To: Members of Dublin City Council
From: Dana L. McDaniel, City Manager 
Date: August 4, 2016
Initiated By: Vincent A. Papsidero, FAICP, Planning Director
Jennifer M. Rauch, AICP, Planning Manager
Re: Tree Replacement Fee Waiver Request – Hawthorne Commons (15-118FDP)

Tree Replacement Fee Waiver Request – Hawthorne Commons (15-118FDP)

15-118FDP
 Final Development Plan
 NE Quad, Subarea 3, Hawthorne Commons
 Wyandotte Woods Blvd. and Emerald Pkwy.

Hawthorne Commons
 Apartments
 Tree Removal Plan

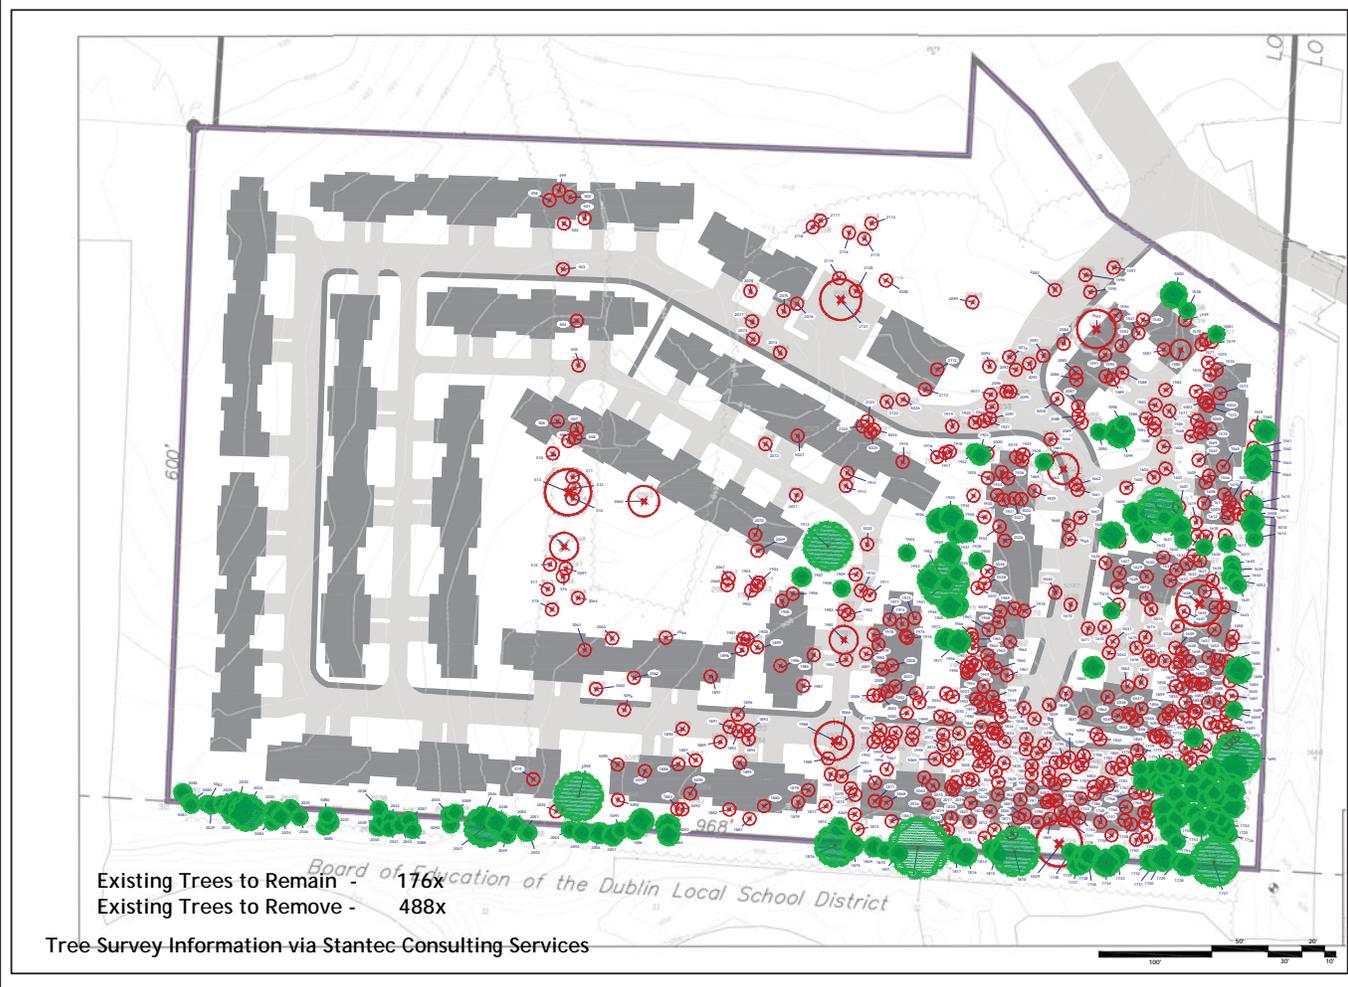
Ms. Salay referred to the landscape plan where the trees that are to remain are green and those to be removed are marked red.
